Eskom Distribution

PROJECT: ELECTRIFICATION OF MDASHE EXT 8

TITLE: 476 CONNECTIONS
LNBG065
LNBG066
LNBG067
LNBG068

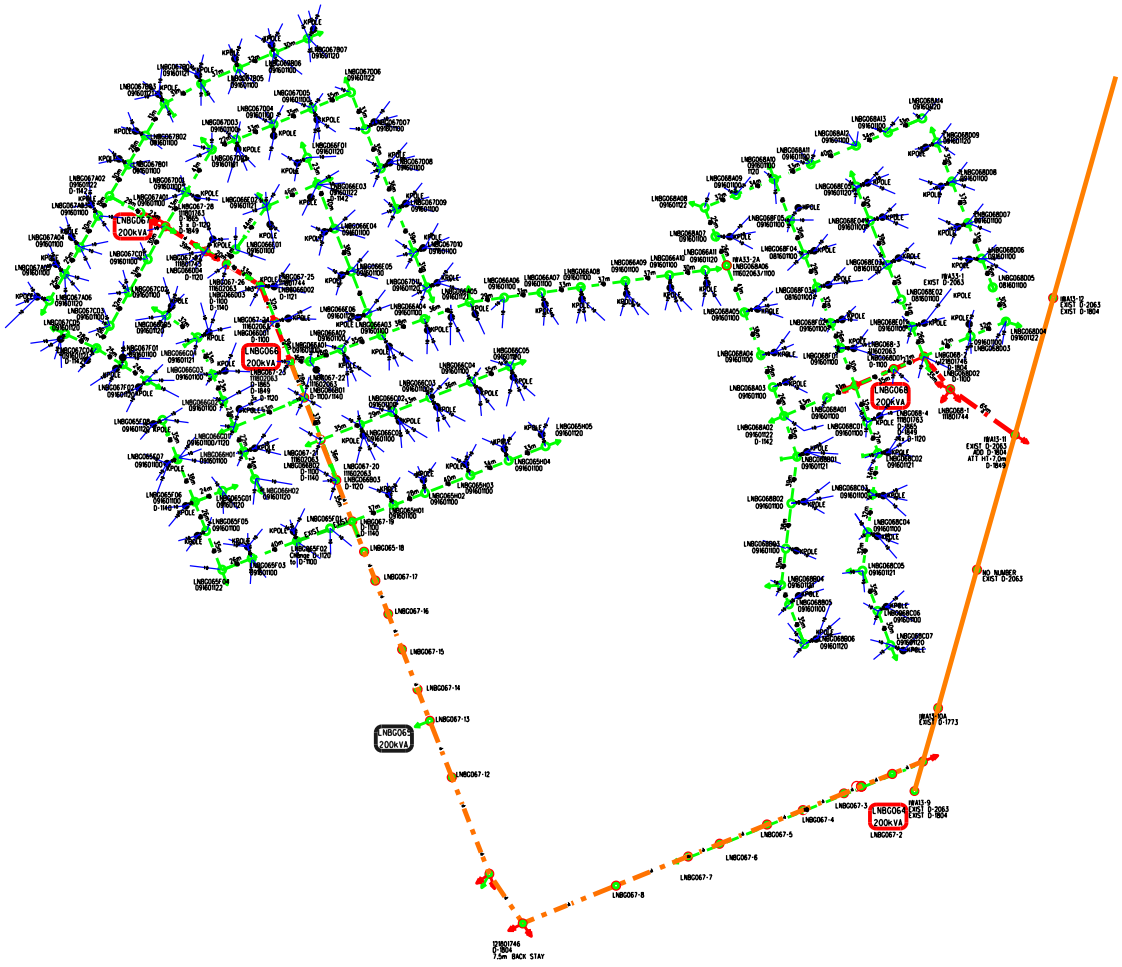
Note
These are following changes, structure LNBG066A04 we moved the bend to the back of the House, use stay wire.
And structure LNBG067B07, use strut pole not stay wire, And the line from structure LNBG067C02 is no longer ToT is just intermediate.
And structure LNBG067E01 is no longer connected to TRFR LNBG067 it is connected to TRFR LNBG066, and change the numbering from LNBG067E01 to LNBG066C05, and use stay wire.
we moved TRFR LNBG066 to the corner fence, and done a stackspan to plce LNBG066A01 put a strut pole.

Please use this spanning sheet, and compare to the other one, you will see the changes.

Note
The following changes were made : We moved structure LNBG068A09 because was in the gate.
And structure LNBG068A10 we changed strut pole to stay wire.
LNBG068A14 change the stay use strut pole,And LNBG068F05 we moved because was in the yard.
LNBG068F01 we moved because it was in the gate, LNBG068A01 we moved to the corner.
